Comment: (Clause 33.2.8, Page 105 line 35, Editor Note #2)

Addressing Editor's Note #2. Its content from D1.7 is shown below. [The text marked blue was modified to make the subject more clear.](#)

Figure 1:

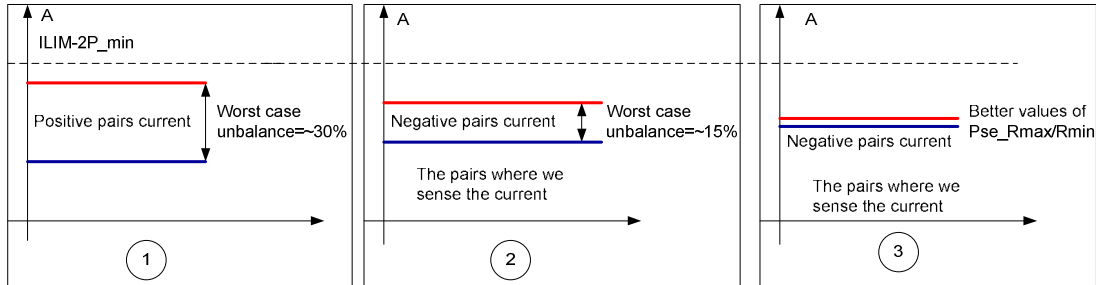
The positive pairs have the worst case unbalance. ILIM-2P\_min is located near the pair with the maximum current marked in RED.

Figure 2:

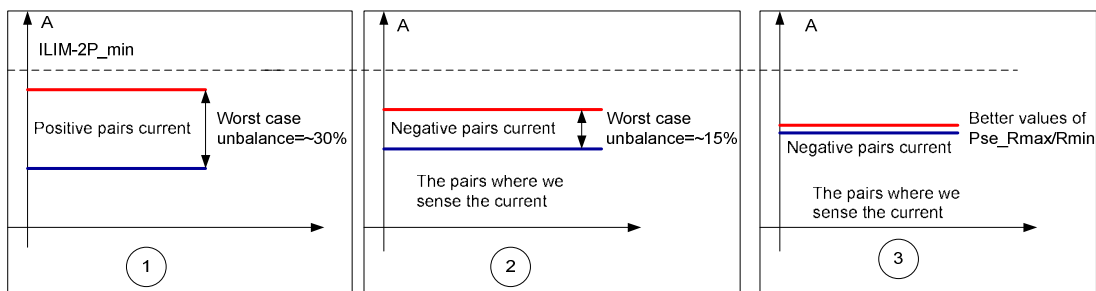
The negative pairs have the lowest unbalance due to the fact that the sense resistors improve unbalance. ILIM-2P\_min is located at the same place in the current spec, pair with the maximum current marked in RED.

The actual ILIM-2P\_min need to be lower than the one needed for the positive pairs in order to protect both the negative and positive pairs in efficient way because increase in the current at the positive pair due to a fault will be translated to lower increase in the negative pair so the actual protection will happen at ~11% above what we expecting.

Figure 3:

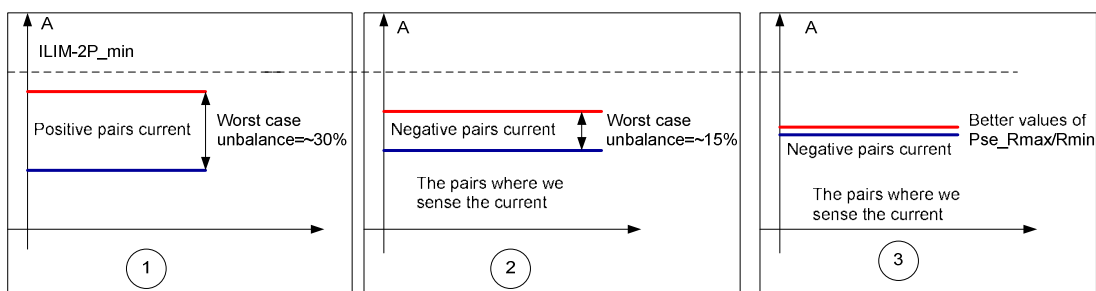
The same case of Figure 2 but with better match of Rpse\_max/min that reduces unbalance. But here, now the ILIM-2P\_min is now further away from the actual current value of the pair with maximum current. This result with the need of big increase in the positive pair current to be sensed at the negative pairs where we do the sensing and control of the current.

The solution is to allow using lower ILIM-2P than specified in Table 33-17 for the pairs we sense the current if we use better values of Rpse\_min/max specified in equation 33-13 that actually reduces unbalance.

Type 3 and Type 4 PSEs that operate over 4-pairs and control the PSE PI pair to pair unbalance with higher values of Rpse\_max and Rpse\_min than those defined by equation 33-13 and have a lower resistance difference (Rpse\_max-Rpse\_min) may use lower values of ILIM-2P\_min and Ipeak-2P, as defined in TBD1 and TBD2.
